RAMP REPORT REGION 2 ADA 2026

Lawerence St., & Ingraham Lane,
Rockland

CR16759

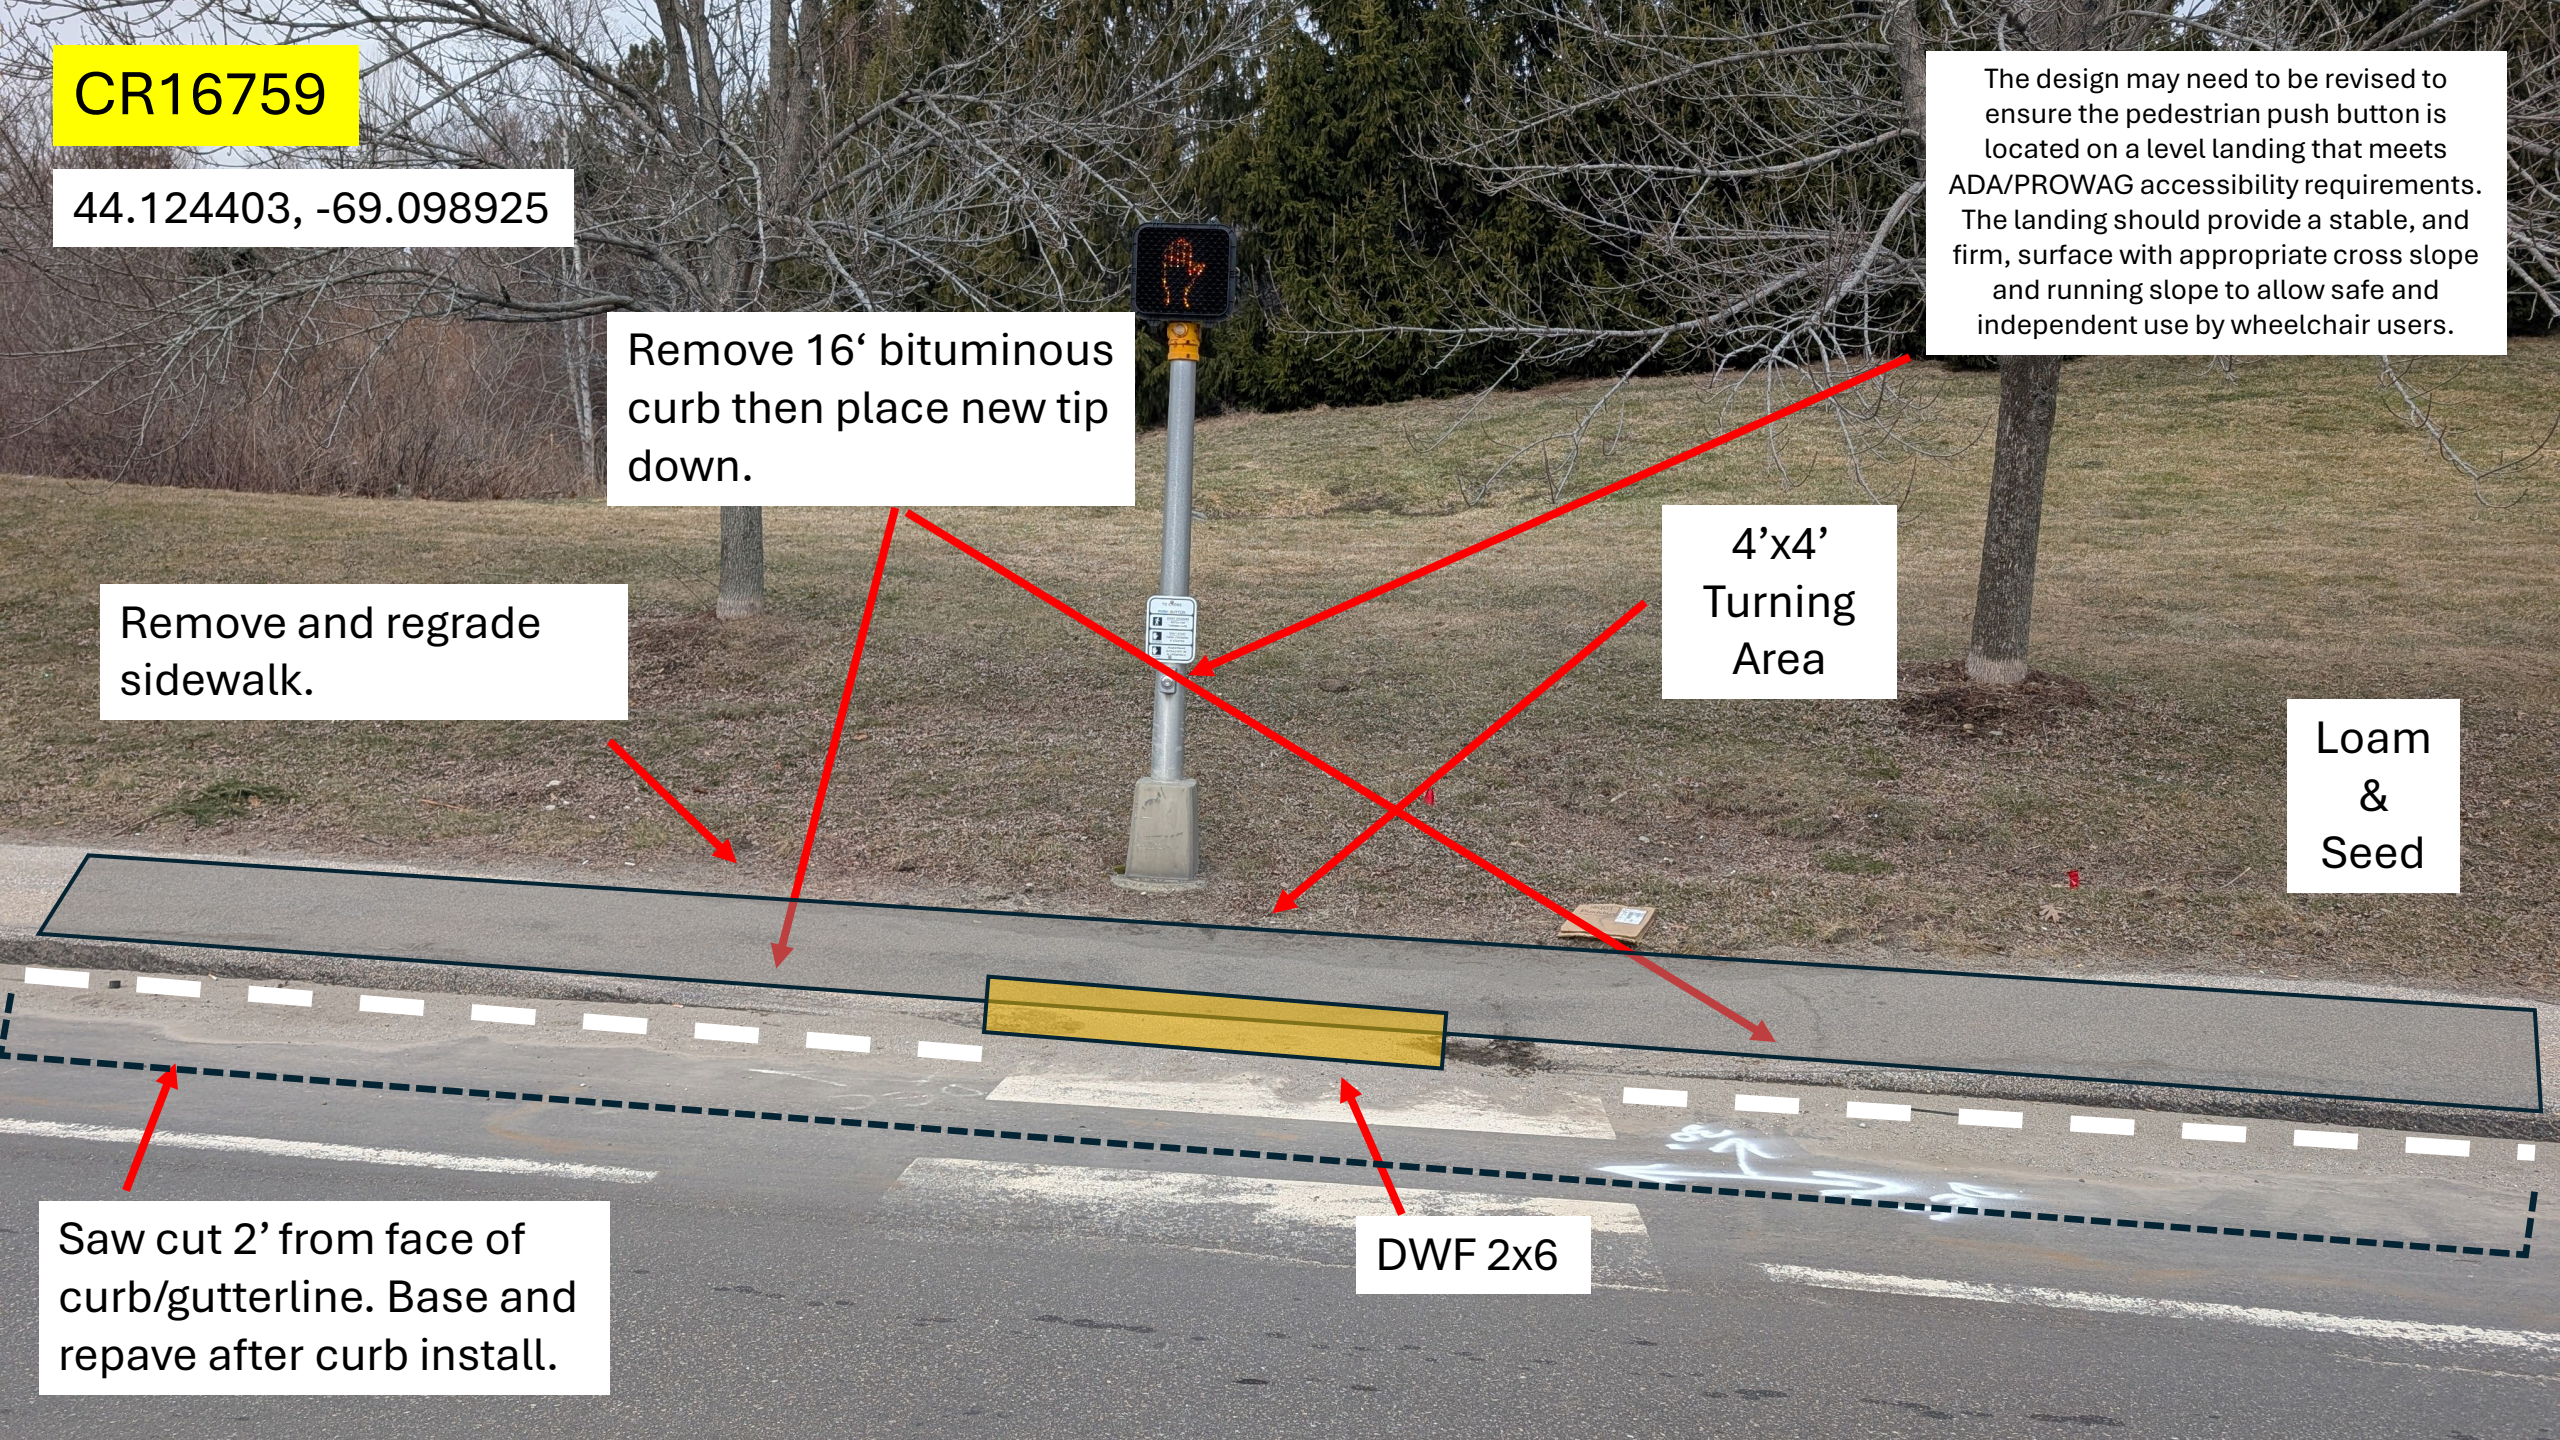
The design may need to be revised to ensure the pedestrian push button is located on a level landing that meets ADA/PROWAG accessibility requirements. The landing should provide a stable, and firm, surface with appropriate cross slope and running slope to allow safe and independent use by wheelchair users.

Remove 16' bituminous curb then place new tip down.

Remove and regrade sidewalk.

4'x4'
Turning
Area

Loam
&
Seed

Saw cut 2' from face of
curb/gutterline. Base and
repave after curb install.

DWF 2x6

CR13664

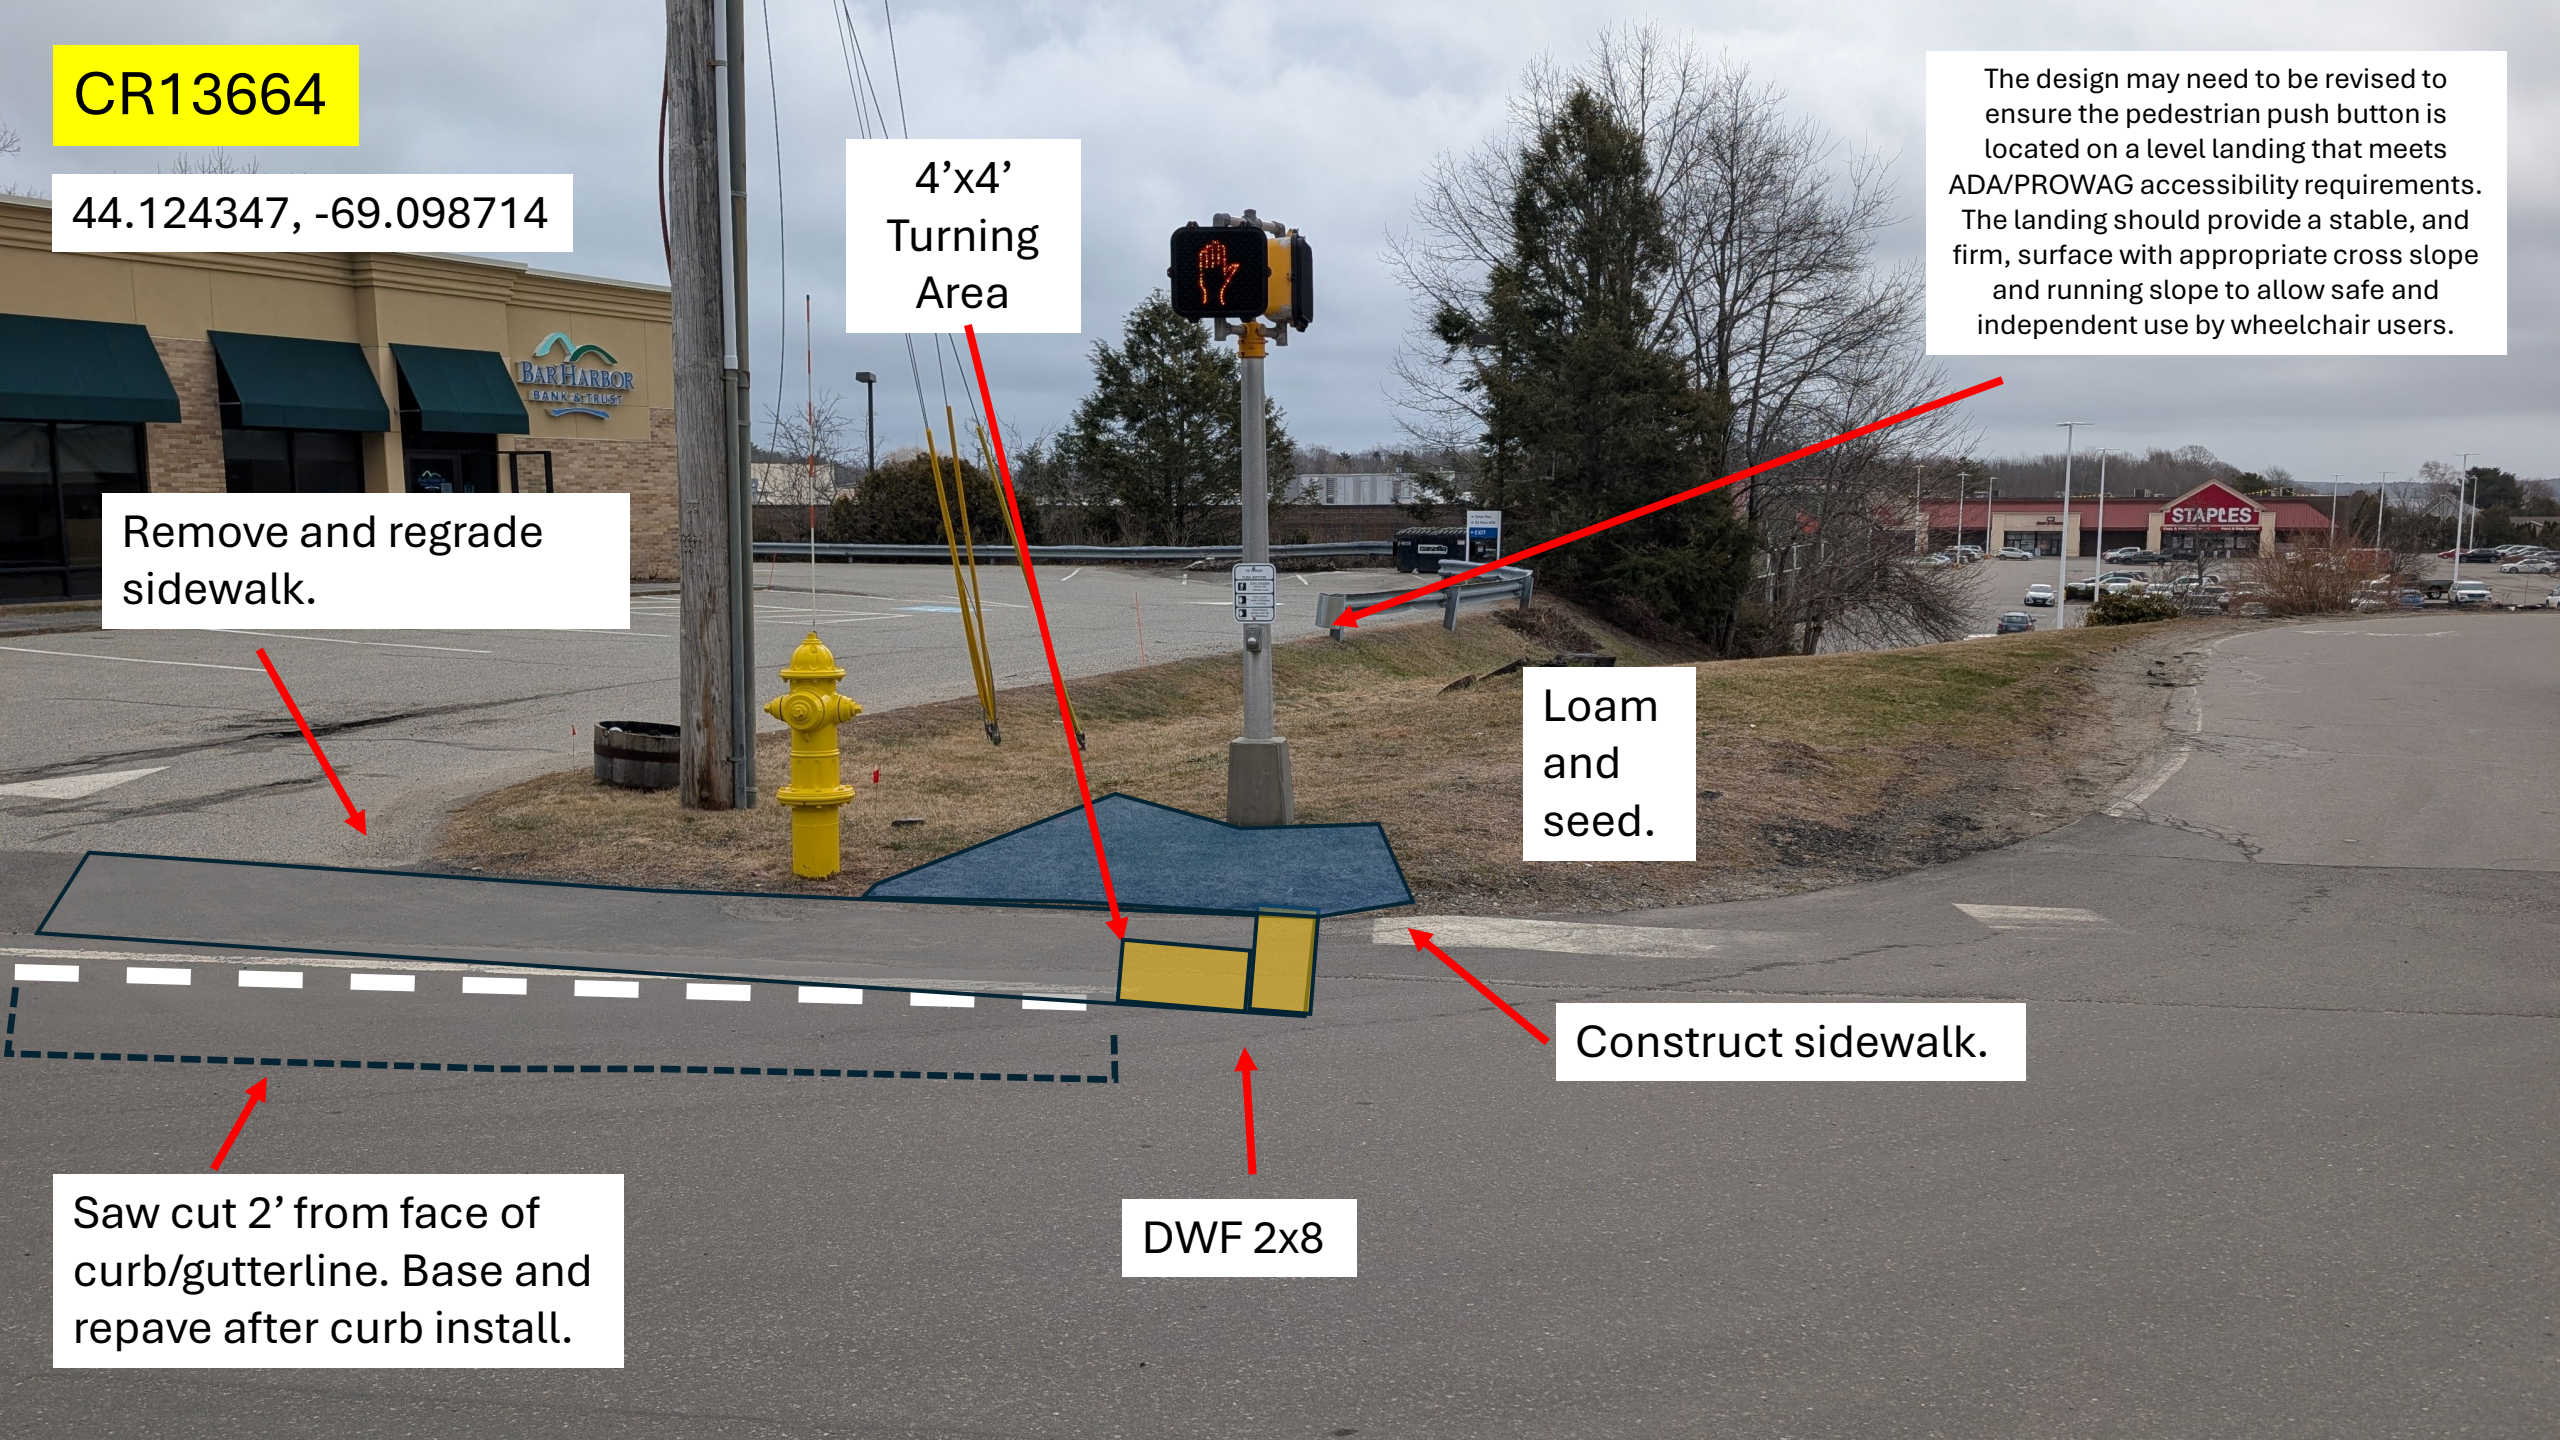
Remove and regrade
sidewalk.

4'x4'
Turning
Area

The design may need to be revised to ensure the pedestrian push button is located on a level landing that meets ADA/PROWAG accessibility requirements. The landing should provide a stable, and firm, surface with appropriate cross slope and running slope to allow safe and independent use by wheelchair users.

Loam
and
seed.

Construct sidewalk.

Saw cut 2' from face of
curb/gutterline. Base and
repave after curb install.

DWF 2x8

CR16758

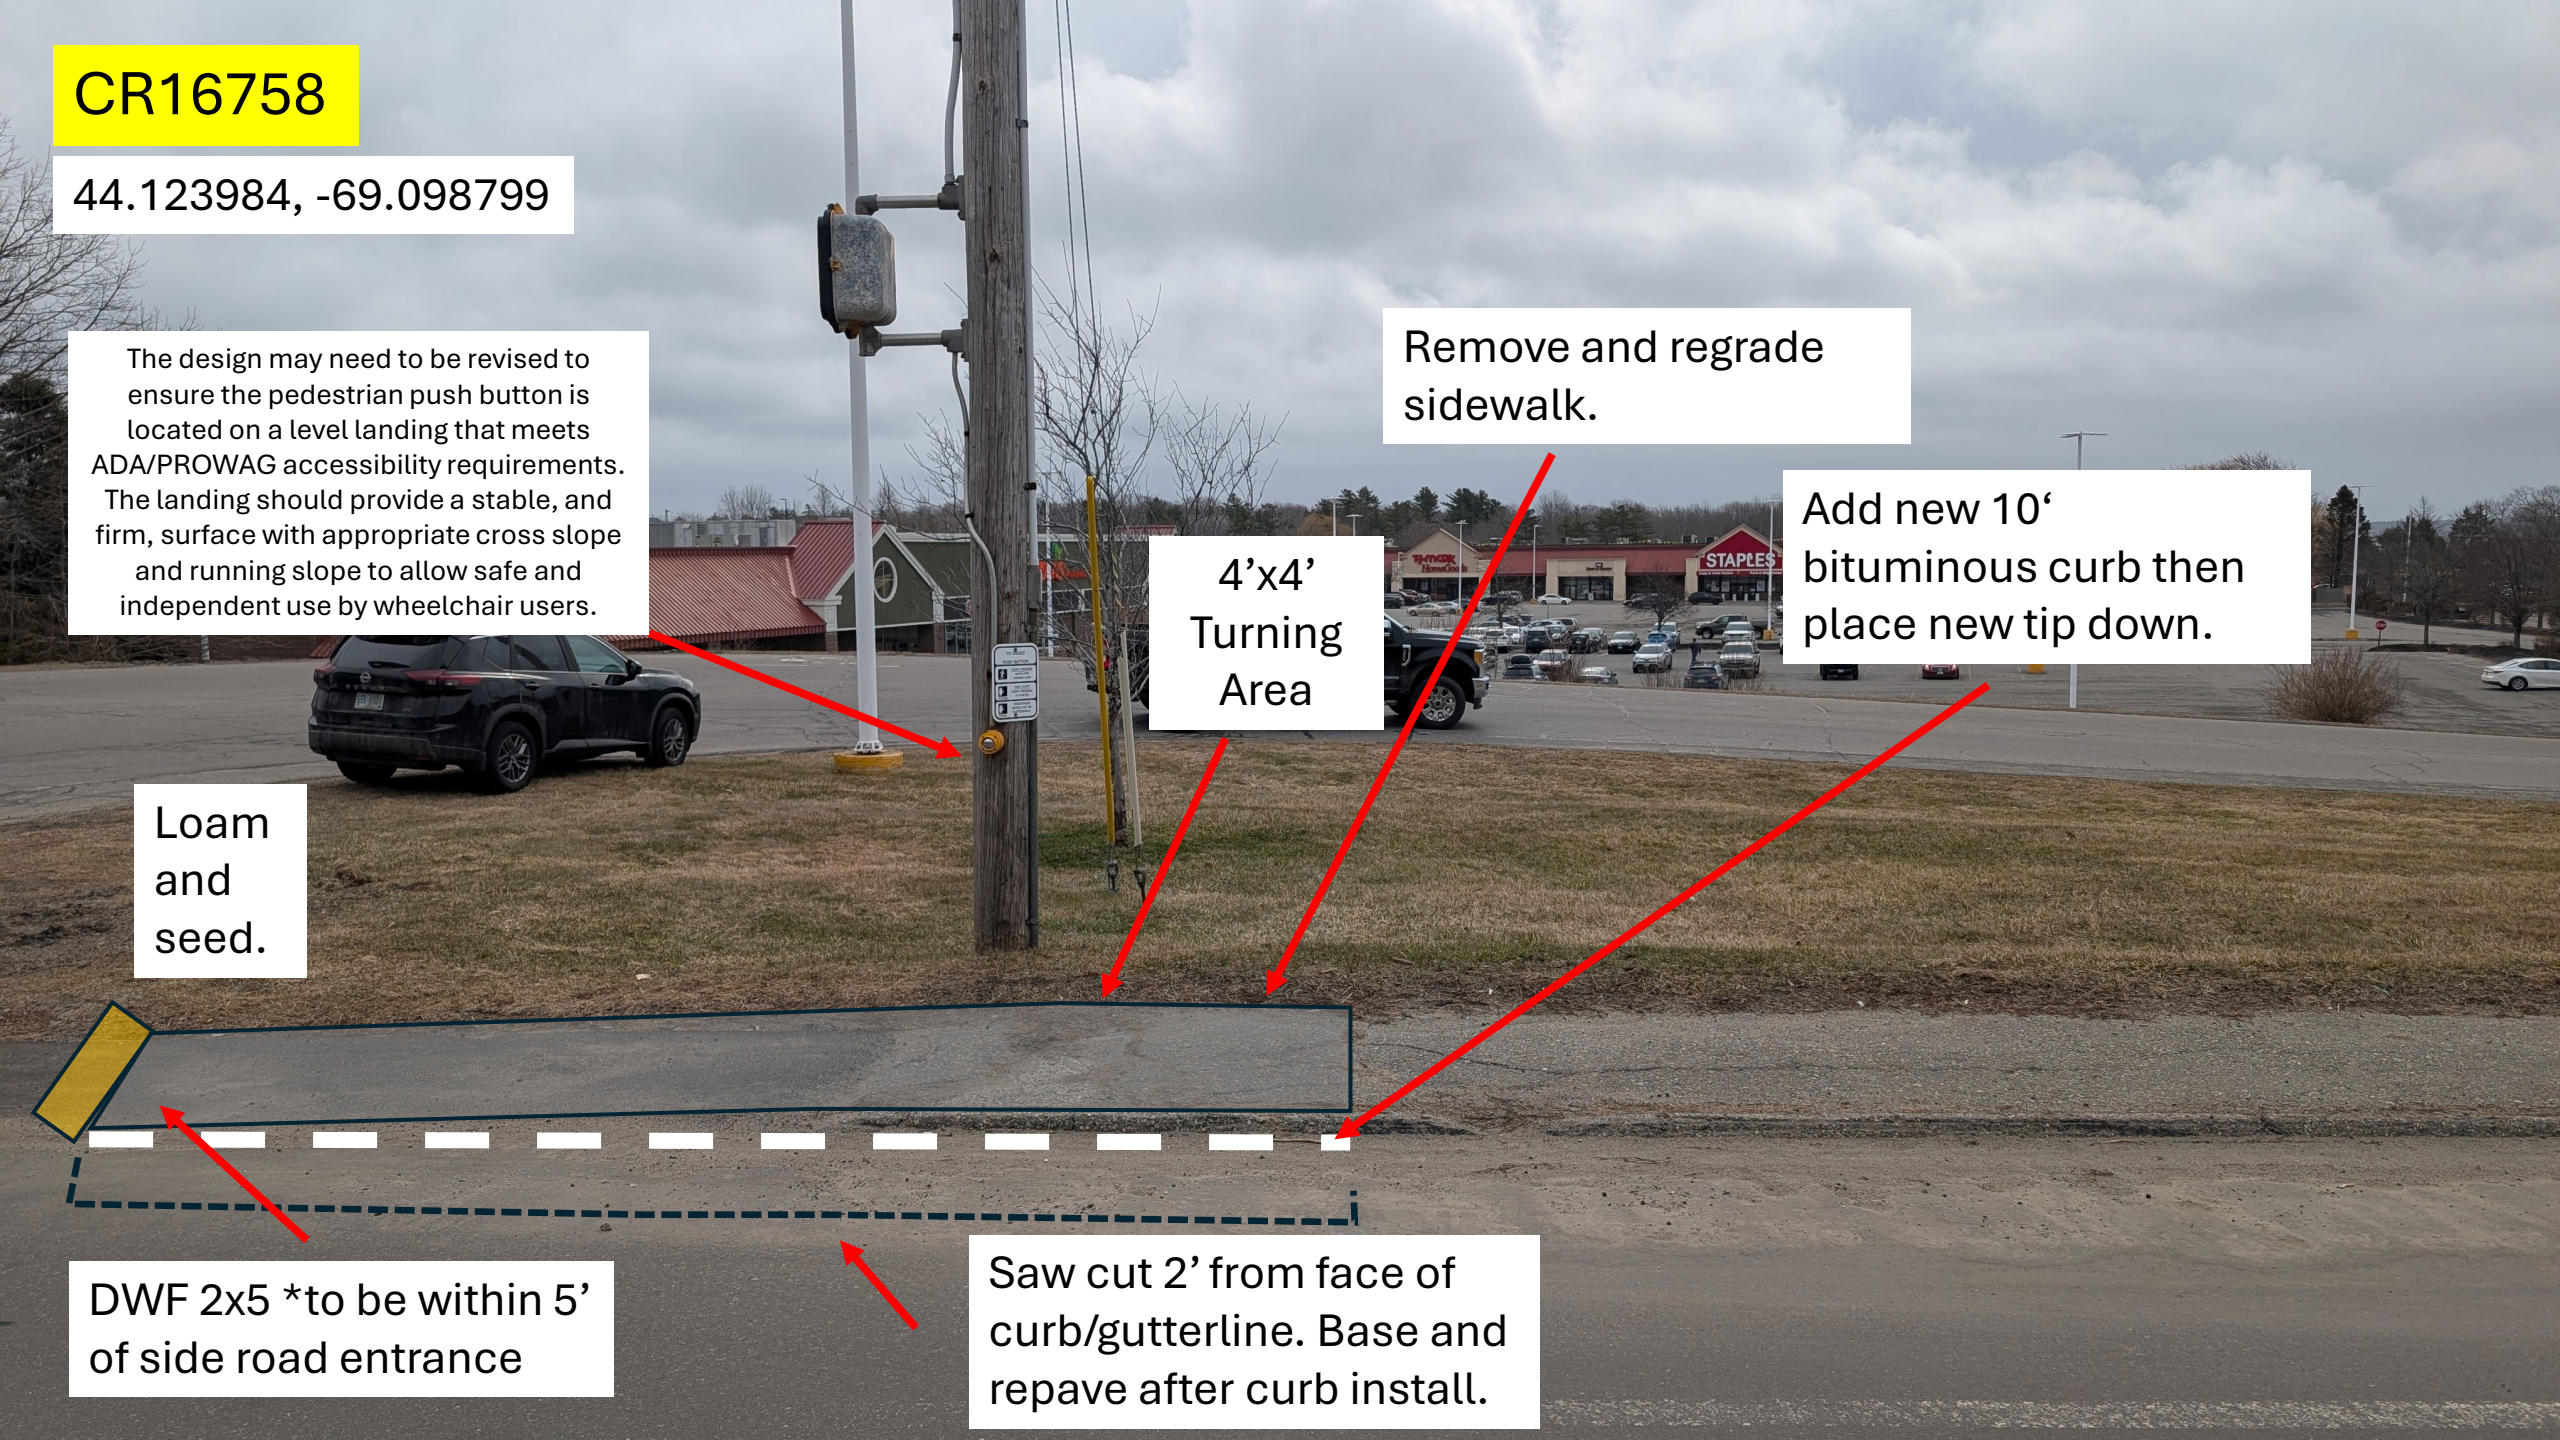
The design may need to be revised to ensure the pedestrian push button is located on a level landing that meets ADA/PROWAG accessibility requirements. The landing should provide a stable, and firm, surface with appropriate cross slope and running slope to allow safe and independent use by wheelchair users.

Remove and regrade sidewalk.

Add new 10' bituminous curb then place new tip down.

4'x4' Turning Area

Loam and seed.

DWF 2x5 *to be within 5' of side road entrance

Saw cut 2' from face of curb/gutterline. Base and repave after curb install.
